CLOUGH HARBOUR & ASSOCIATES LLP

June 30, 2008

**RE: Rapp Road Waste Management Facility – DEC # 4-0101-171/11
Eastern Landfill Expansion Part 360 Permit Application – Addendum No. 2
Response to April 18, 2008 DEC Notice of Incomplete Application
CHA Project No. 12206.4005.1502**

G-11

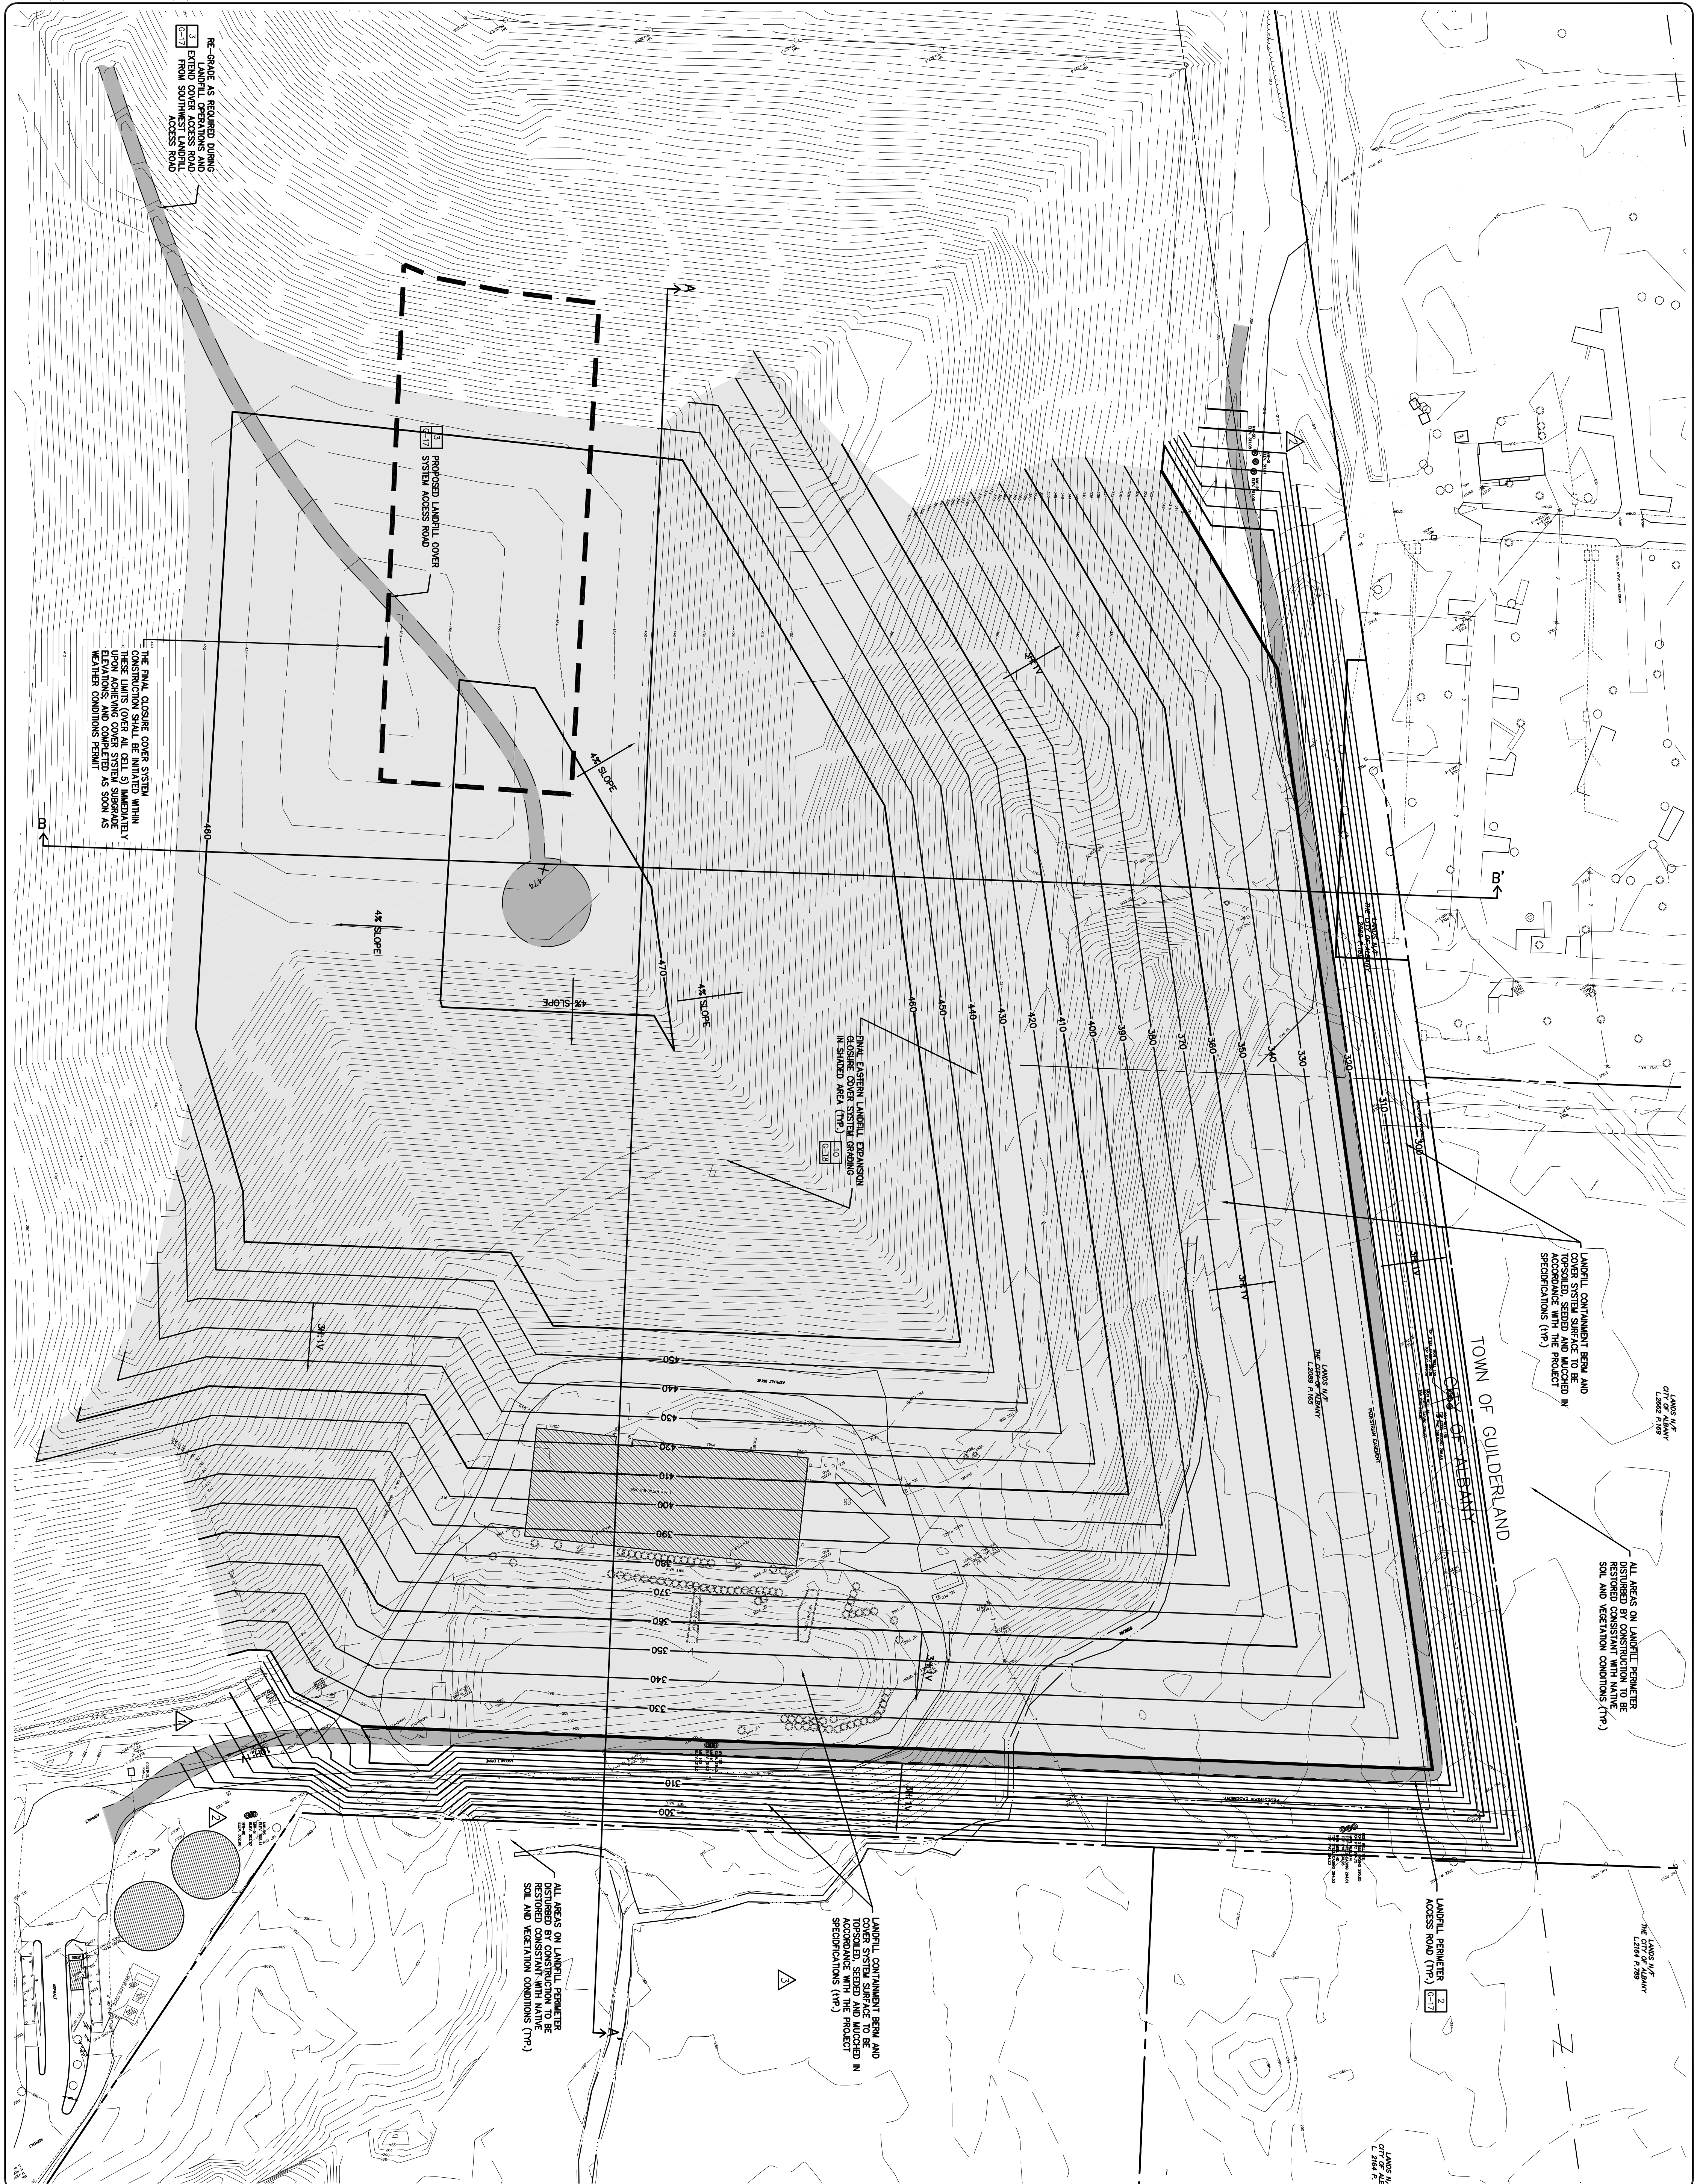
In addition to the problems with cells 10 and 11 discussed above, there have been other liner system problems identified for various cells for the period since 2003, as indicated in the attached table. 6 NYCRR Part 360-2.13(i) requires that "For lateral expansions adjacent to existing landfills, the department may approve encroachment on the existing landfill's side slope if a leachate barrier system is designed and constructed to minimize leachate migration into the existing landfill." Therefore, if an overfill liner is not to be constructed in this case, a variance application demonstrating the adequacy of the existing liner system, including the leachate collection and removal systems, must be submitted and approved.

Subsequent to the April 24, 2008 meeting, Mr. Dave Lasher of the NYSDEC contacted CHA to discuss the ALR readings for cell 5. Mr. Lasher indicated that ALR has been above the regulatory limit since late December 2007 and has oscillated above 20 g/a/d for the past several years. As indicated above, flushing of the leachate collection lines has reduced the ALR in the past and was recently performed on May 12, 2008. The flushing event appears to have had a positive impact on the cell 5 performance as the daily ALR has declined to 11.7 g/a/d and the 30-Day ALR has declined to 18.3 g/a/d in cell 5. Based on discussions with Mr. Thomas Reynolds of the NYSDEC regarding the elevated ALR in cell 5 and the remediation efforts performed in the past, we propose to fill the expansion area over cell 5 first then construct the final closure cap over the cell 5. Fill progression has been modified to complete waste placement in the cell 5 area to the proposed final closures grades for the Eastern Expansion. The proposed Solid Waste Progression plan (Drawing G-13) and the Final Closure/Landscape/Stormwater Control Plan (Drawing G-11) are included as Attachment 7.

As indicated in the comment above, NYCRR Part 360-2.13(i) requires a leachate barrier be constructed over existing landfill side slopes for lateral expansions to minimize leachate migration into the existing landfill. The proposed Eastern Expansion project will overlay the side slopes of cells 1, 9, 10 and 11 of the Albany Interim Landfill that have been constructed in accordance with NYCRR Part 360 regulation; therefore, a leachate barrier will not be constructed over the overlay areas of the existing landfill. Leachate generation for the existing landfill with the proposed overlay will decrease or remain the same due to the additional waste placement; therefore, the leachate collection and removal systems for the existing landfill are sufficient. An application for variance from NYCRR Part 360-2.13(i) is included as Attachment 7.
